Departmental Comments	Responses to Comments
1.	<b>Comments from Environmental Protection Department</b>	
	<u>Planning Statement</u>	
1.1	Section 9.2.4: In view of the comments on the SIA report, please propose the respective upgrading works on the downstream sewer which identified over capacity.	Section 9.2.4 of the Planning Statement has been revised to tally with the latest findings in the revised Sewerage Impact Assessment (SIA). Please refer to the replacement pages of Planning Statement under <b>Appendix A</b> .
	<u>Environmental Assessment Report</u>	
	<u>Air Quality</u>

Section 16 Planning Application for Proposed Residential Development with Minor Relaxation of Plot Ratio Restriction at Lots 1027, 1029, 1030, 1034A, 1034B, 1039 (Part), 1040, 1042 RP, 1043 RP, 1044 RP (Part), 1045, 1047, 2233 (Part), 2251 S.A RP, 2256 RP, 2315 (Part) and 2316 RP (Part) in D.D. 92 and Adjoining Government Land (New Lot to be known as Lot 2644 in D.D. 92), Kwu Tung South, Sheung Shui, the New Territories (Application No. A/NE-KTS/565)

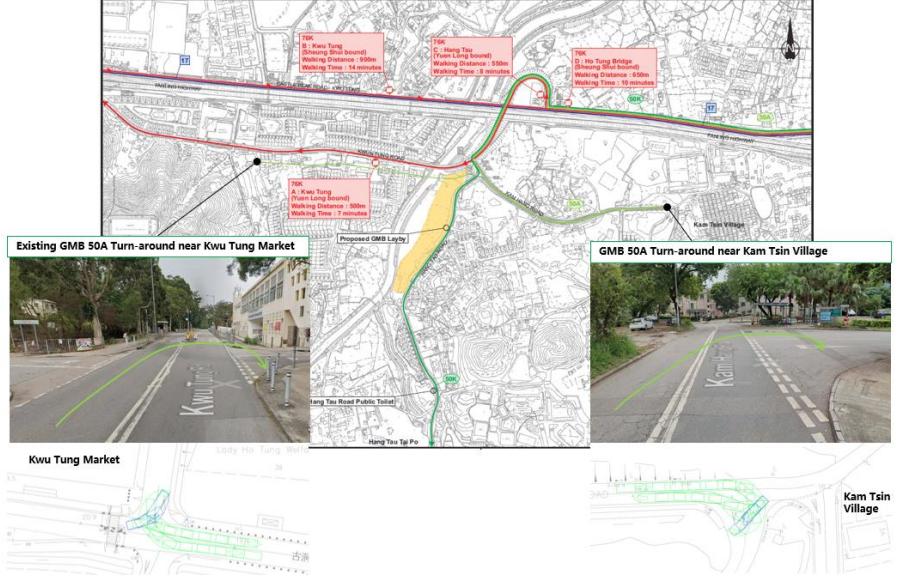
6.5	<p>Figure 3.5 (Indicative Section Plan): Please advise if the voids located at G/F of T3A and T2B are permeable from east to west of the application site. (i.e. Area shown in yellow in the extract plan below).</p>	<p>The voids are permeable from northwest to southeast of the Application Site. To further enhance the permeability, these voids are strategically positioned to be adjacent to the proposed building gaps as indicated in Figure 3.4 of the Planning Statement, which is extracted below for easy reference. The location of voids are also circled in the extract plan below.</p>

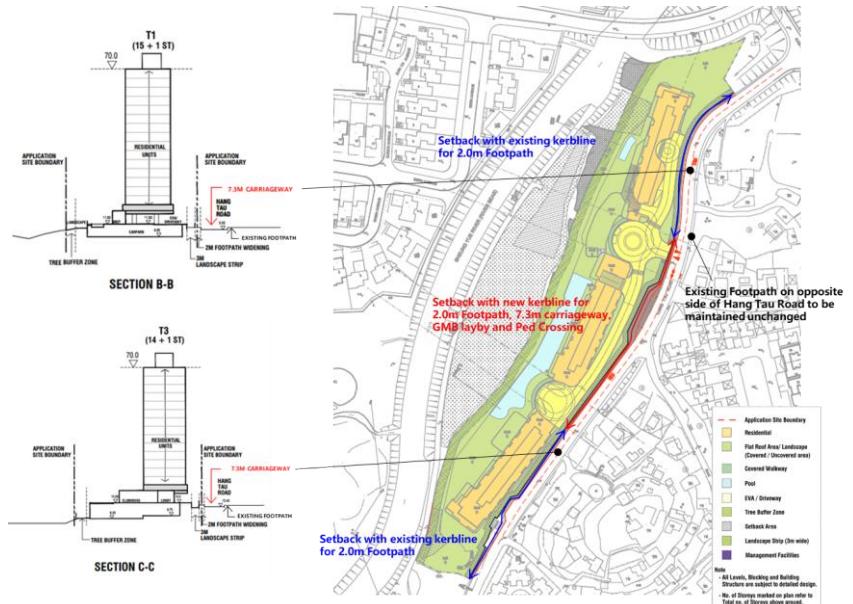
6.7	Please clarify and indicate from relevant plans the extent of the road improvement works to be carried out by the applicant. It is noted from Figure 3.13 that the footpath on both sides of Hang Tau Road is included in the proposed footpath widening scheme, hence please make sure the portion related to the applicant's road widening proposal are reflected clearly on Figure 3.13. If Hang Tau Road 7.3m widening works is not provided by the applicant or if the footpath opposite to the site is not covered by the said proposed road-	<p>Please refer to Figure A attached under <b>Appendix F</b> for the extent of the road improvement works. Figure 3.13 of the Planning Statement (see <b>Appendix A</b>) has been revised to accurately reflect its extent.</p> <p>Regarding the opposite side of Hang Tau Road footpath, portion of it will be modified by the Applicant of Application No. Y/NE-KTS/17. Under No. Y/NE-KTS/17, the junction of Kam Hang Road and Hang Tau Road will be improved with provision of 2m footpath near the junction.</p>

Departmental Comments	Responses to Comments
	<p>widening, it should not be considered as a “design merit” or a “plan gain”.</p>	<p>Also, there are existing settlements along the eastern side of Hang Tau Road footpath, such as Casas Domingo, involving 3<sup>rd</sup> party lots. Widening of footpath along that side by the Applicant is therefore infeasible.</p> <p>To provide planning gains, the Applicant has proposed provision of GMB layby and pedestrian crossing facilities. These planning gains were accepted under the previous rezoning Application No. Y/NE-KTS/15 and are maintained in the current planning application.</p>

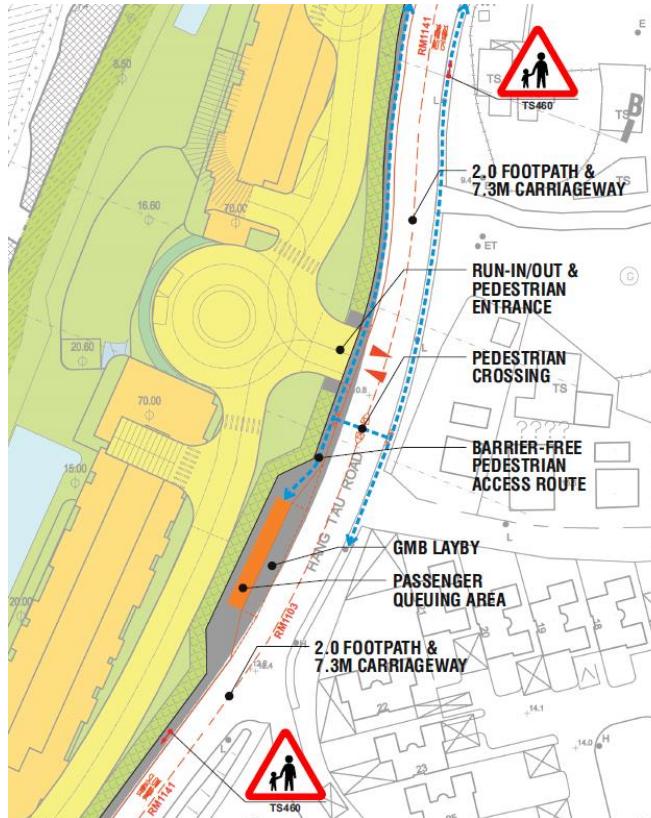
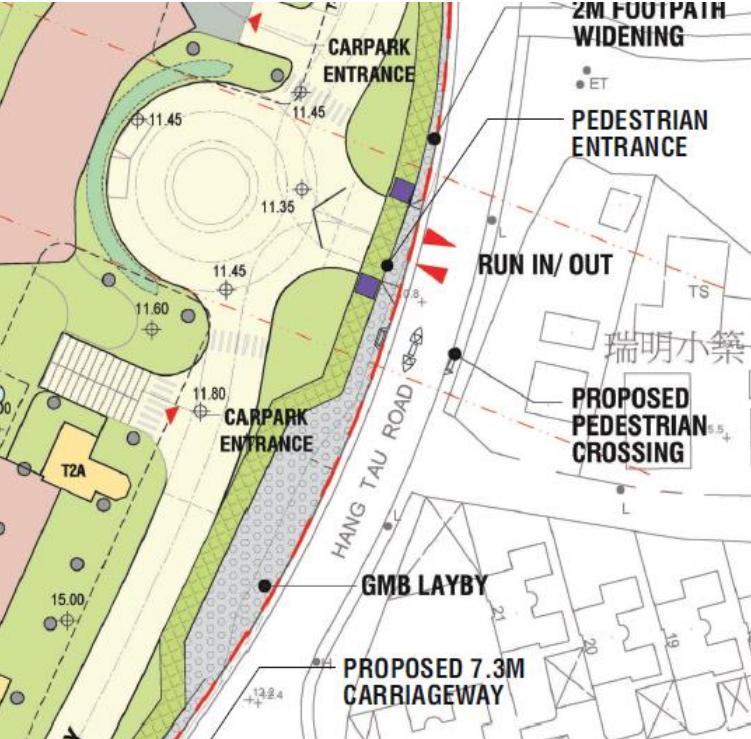
7.	<b>Comments from Transport Department</b>	
	<u>Comments from Traffic Engineering NT Division</u>	
7.1	R-t-C Item 4.1 & Para. 3.5.1: Our previous comment regarding the extent of the proposed widening of existing Hang Tau Road into 7.3m carriageway has not been fully addressed in the R-t-C. Please provide a layout plan about the extent of the Hang Tau Road widening works and provide a cross section of the carriageway indicating the lane width and marginal strip. Please also advise the road drain and public lighting provision of the proposed road.	<p>With reference to the approved S12A Planning Application (No. Y/NE-KTS/15), the proposed extent of road improvement works will be covered by the "Setback Area" along Hang Tau Road abutting the Application Site.</p> <p>As shown by the relevant plan and cross sections in Drawings 3.2 and 3.3 of the revised TIA enclosed under <b>Appendix H</b>, the proposed setback areas are indicated for the road improvement works along Hang Tau Road, which includes:</p> <ul style="list-style-type: none"> <li>• 7.3m carriageway</li> <li>• 2.0m footpath abutting site boundary only</li> </ul>

Departmental Comments	Responses to Comments
		<ul style="list-style-type: none"> <li>• A GMB layby with queuing area on Hang Tau Road</li> <li>• A cautionary pedestrian crossing across Hang Tau Road</li> </ul> <p>The setback area, which includes the public footpath and GMB layby outside the development, will be handed over for management and maintenance by the Government at their own costs.</p>  <p>As updated in Para. 3.5.6 and shown in Drawing 3.4 in the TIA, the existing footpaths along Hang Tau Road have an effective width of 1.0m (excluding railing and street furniture such as fire hydrant as shown in photo), which can be operated within LOS A (16 peds/m/min) with anticipated population intake of the proposed development and passage of wheelchair.</p>

Departmental Comments	Responses to Comments
		 <p>Existing Footpath with effective width 1.0m (excluding railing &amp; street furniture)</p> <p>Proposed 2.0m Footpath with Setback</p> <p>Existing Footpath with effective width 1.0m (excluding railing &amp; street furniture)</p> <p>Existing Footpath with effective width 1.0m (excluding railing &amp; street furniture)</p> <p>Details of road drain and public lighting design will be submitted with the General Building Plans following the approval of S16 planning application.</p>

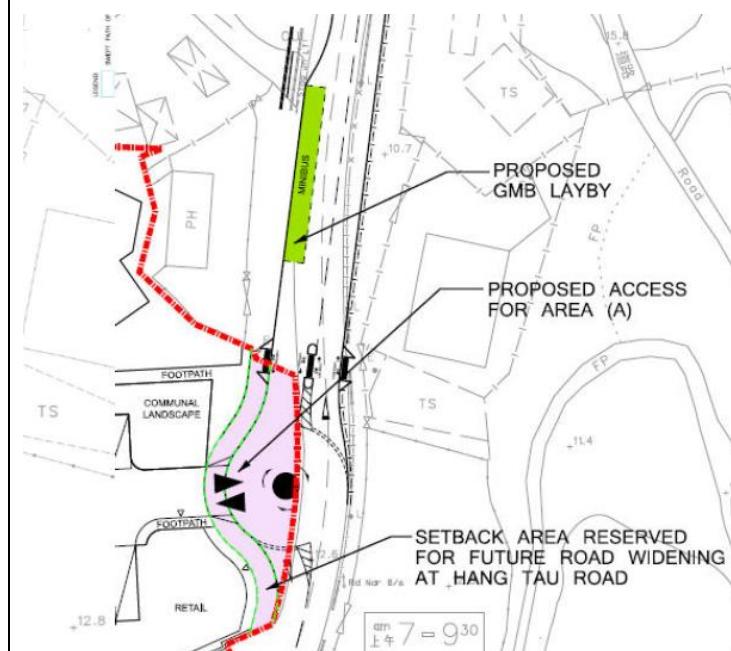
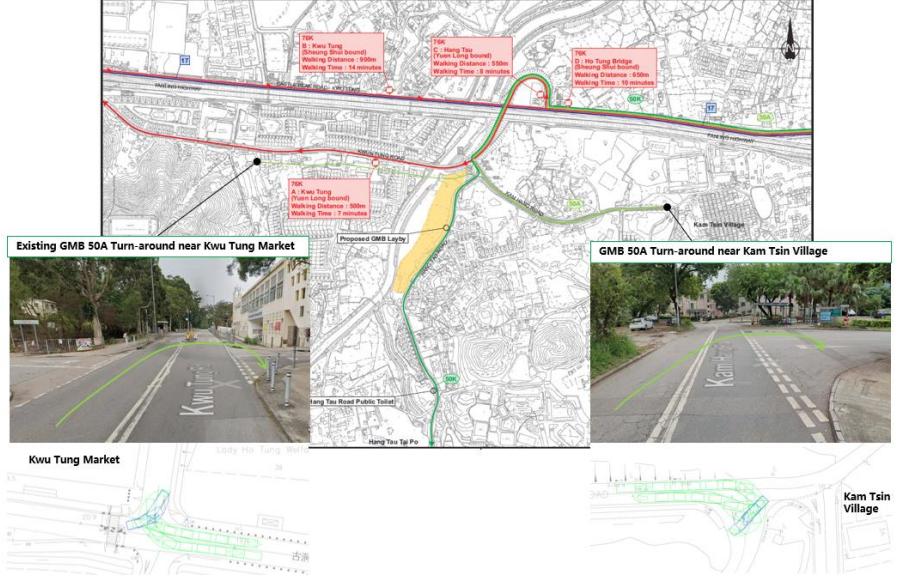
7.2	<p>R-t-C Item 4.3 &amp; Para. 3.5.1: We have provided comments on S12A Planning Application (No. Y/NE-KTS/15) concerning the proposed mini-roundabout. Considering it is not a cul-de-sac but with multi-directional traffic movements and pedestrian movement across the run-in of the development, as well as the turning constraint of long vehicles, please study if the mini-roundabout can be converted into a priority T-junction.</p>	<p>Please be clarified that the concerned mini-roundabout was proposed under a separate approved S12A Planning Application (No. Y/NE-KTS/13) further south of Hang Tau Road, which was intended to facilitate the turnaround of GMB along Hang Tau Road.</p> <p>As updated in Para. 4.2.4 – 4.2.5 in the TIA enclosed under <b>Appendix H</b>, it is understood that the design of the turnaround facility is currently under discussion between TD and the applicant of the other application. Whether it is an external mini-roundabout or any other form of turnaround facilities, it is understood that a turnaround to facilitate the routing of GMB will be available upon the completion of the other development.</p> <p>In case that <u>this permanent GMB turnaround by others</u> is not completed on time for the intake of the subject Application Site, the GMB can still turn around near the south of Hang Tau Road Public Toilet with swept path analysis in Annex E of the TIA as an alternative arrangement based on existing road layout, subject to the GMB trial run on-site.</p>

Departmental Comments	Responses to Comments
		<ul style="list-style-type: none"> <li>8m GMB U-turn near Hang Tau Road Public Toilet (Temporary Arrangement)</li> </ul>  <p>This temporary turn-around arrangement is comparable to the current operation of GMB 50A near Kam Tsin Village and Kwu Tung Market with a similar service level of 10-15 minutes during peak hours, as shown in the following swept path analysis in Annex E of the TIA:</p>

Departmental Comments	Responses to Comments
		<ul style="list-style-type: none"> <li>Existing Turn-around Arrangement for GMB 50A</li> </ul>
7.3	<p>For the junction assessment in Annex B,</p> <ul style="list-style-type: none"> <li>Please clarify the lane width W c-b and visibility Vr-c-b adopted for "J1 with improvement" and lane width W b-a and W b-c adopted for "J2 with improvement".</li> <li>DFCb-c (0) and simultaneous queuing at minor road for "J2 with improvement" shall be included into the calculation. Please clarify.</li> </ul>	<p>The input parameters of junction assessment have been reviewed in Annex B of the TIA under <b>Appendix H</b>.</p> <p>The results of junction performance have also been updated in Tables 2.2 and 5.2 of the TIA respectively. This does not constitute any change in the study findings and conclusions.</p>

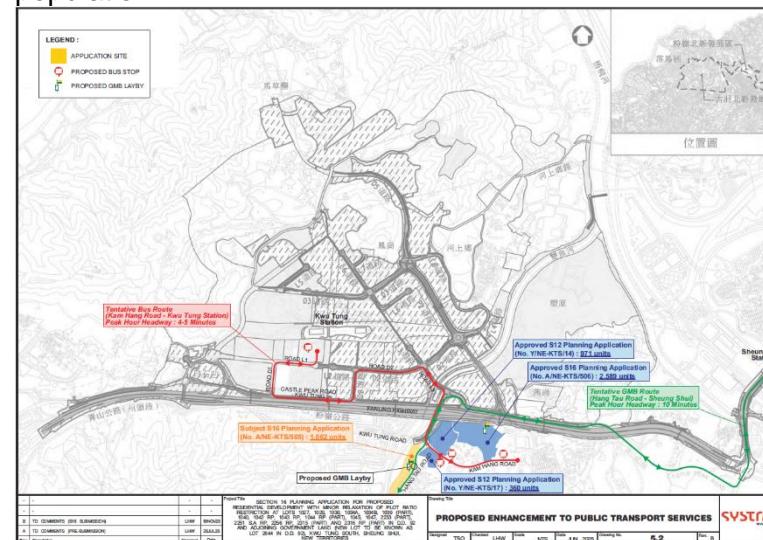
7.11	<p>Para. 3.5.2: Please advise whether the developer will be responsible for the design, construction and maintenance of the new turnaround facility, which the TD Traffic Engineering NT Division advised you to adopt a priority T-junction and provide the design for their comment. If priority T-junction is adopted, the GMBs would <u>not</u> be able to</p>	<p>Please be clarified that the concerned mini-roundabout was proposed under the other approved S12A Planning Application (No. Y/NE-KTS/13) further south of Hang Tau Road. <u>This roundabout by others</u> is intended to facilitate the turnaround of GMB along Hang Tau Road.</p>

Departmental Comments	Responses to Comments
	<p>turnaround to operate your proposed route between this private residential development and Sheung Shui Station. Please refer to our previous comment advising the applicant to consider to provide new turning space / roundabout <b>within</b> this private residential development for 8m GMBs to operate between this development and Sheung Shui Station.</p> <p><u>Extract of TIA Annex E – Swept Path Analysis for GMBs</u></p> 	<p>As updated in Para 4.2.4 – 4.2.6 in the TIA under <b>Appendix H</b>, it is understood that the design of the turnaround facility is currently under discussion between TD and the applicant of the other application. Whether it is an external mini-roundabout or any other form of turnaround facilities, it is understood that a turnaround to facilitate the routing of GMB will be available upon the completion of the other development.</p> <p>In case that <u>this permanent GMB turnaround by others</u> is not completed on time for the intake of the subject application site, the GMB can still turn around near the south of Hang Tau Road Public Toilet with swept path analysis in Annex E of the TIA as an alternative arrangement based on existing road layout, subject to the GMB trial run on-site.</p> <ul style="list-style-type: none"> <li>• 8m GMB U-turn near Hang Tau Road Public Toilet (Temporary Arrangement)</li> </ul>  <p>This temporary turn-around arrangement is comparable to the current operation of GMB 50A near Kam Tsin Village and Kwu Tung Market with a similar service level of 10-15 minutes during peak hours, as shown in the following swept path analysis in Annex E of the TIA:</p>

Departmental Comments	Responses to Comments
		<ul style="list-style-type: none"> <li>Existing Turn-around Arrangement for GMB 50A</li> </ul> 
7.12	<p>Para. 3.5.2: While we note from the response of the applicant that they will be responsible for the design and construction of their proposed new GMB layby and passenger queuing area at their own costs, they have not addressed our enquiry on management and maintenance and associated costs for these facilities. Please advise.</p>	<p>Please be clarified the proposed GMB layby and passenger queuing area, which are indicated as "Setback Area" in the Master Layout Plan as part of the public footpath, will be handed over to Government Departments for management and maintenance at Government's cost.</p>
